REVIEW OF THE REVISED
MILLSTONE UNIT 3 PROBABILISTIC SAFETY STUDY
SEISMIC FRAGILITY

John W. Reed

Lawrence Livermore National Laboratory

May 4, 1984

FIGURE 2-1. MILLSTONE RESPONSE SPECTRA FOR 10% DAMPING

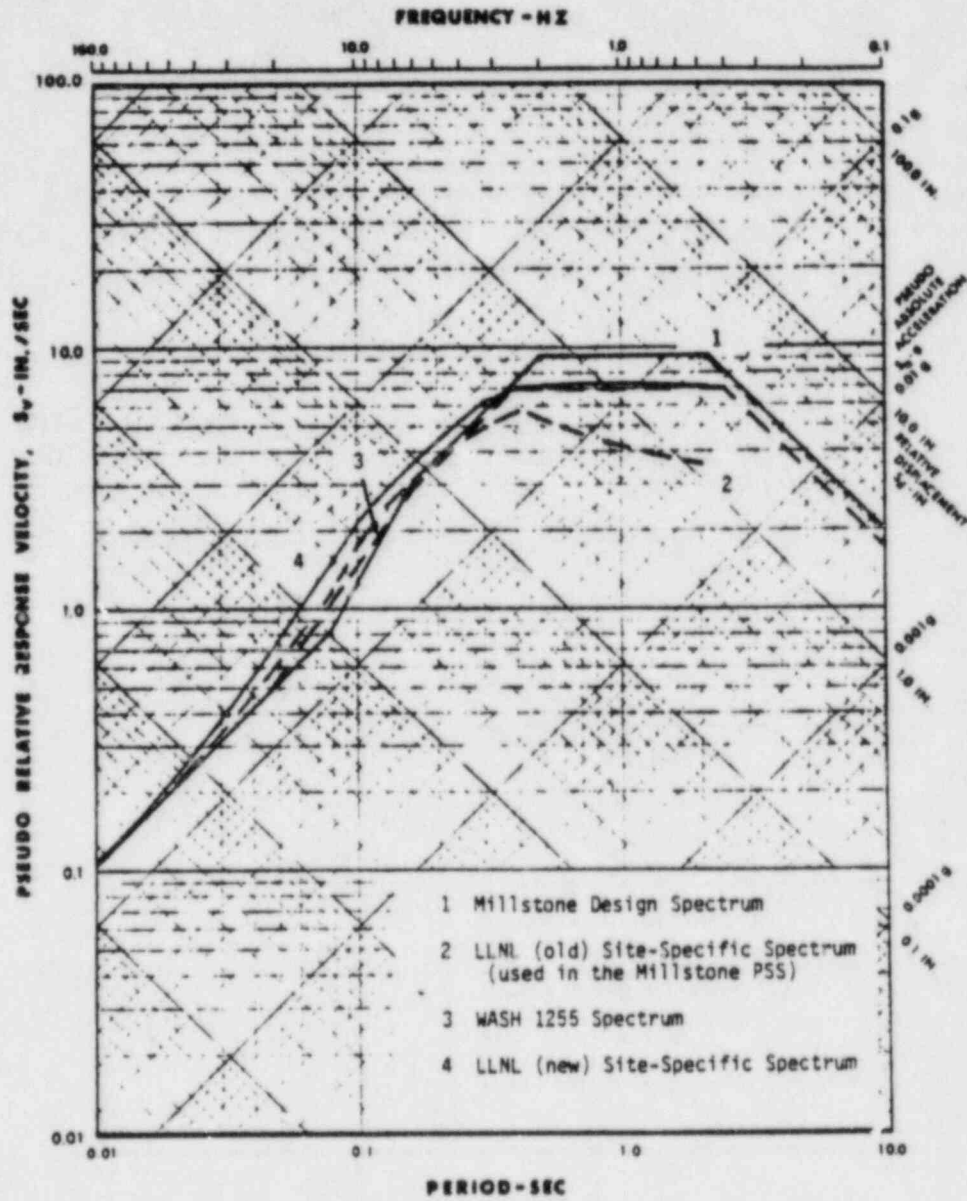
The response spectrum shape for earthquake magnitudes in the range 5.3 to 6.3 developed in Reference 11 for rock sites was used. Figure 2-1 shows this spectra with the Millstone design spectra for 10 percent damping. The procedure described in Reference 11 to convert the 5 percent damped spectrum to 10 percent damping was used. Each spectrum in the figure is scaled to 0.17g, the SSE level. Also shown in the figure is the WASH 1255 broad-band response spectrum.

In addition to these spectra, LLNL (Ref. 13) has conducted a new seismic hazard analysis for the Millstone site. In Figure 2-1, the 1000 year return period spectral shape scaled to 0.17g is shown.

Based on the comparison in Figure 2-1 we find that the magnitude-dependent spectra are generally higher than the design spectra for frequencies greater than 5 Hz. Among these, the most recent spectra developed by LLNL has the highest spectral level. At frequencies less than 5 Hz, the design spectrum exceeds the site-specific spectrum, with the greatest variations occurring at frequencies less than 2 Hz.

In comparison to the WASH 1255 broad-band spectra, the LLNL site-specific spectra both have higher spectral levels at frequencies beyond 5 Hz. In the 2-5 Hz region, the WASH 1255 is higher.

4. The NRC should determine if the site-specific spectrum used in the fragility analysis is appropriate. See Table 2-1 and Figure 2-1 for a comparison of different response spectra.
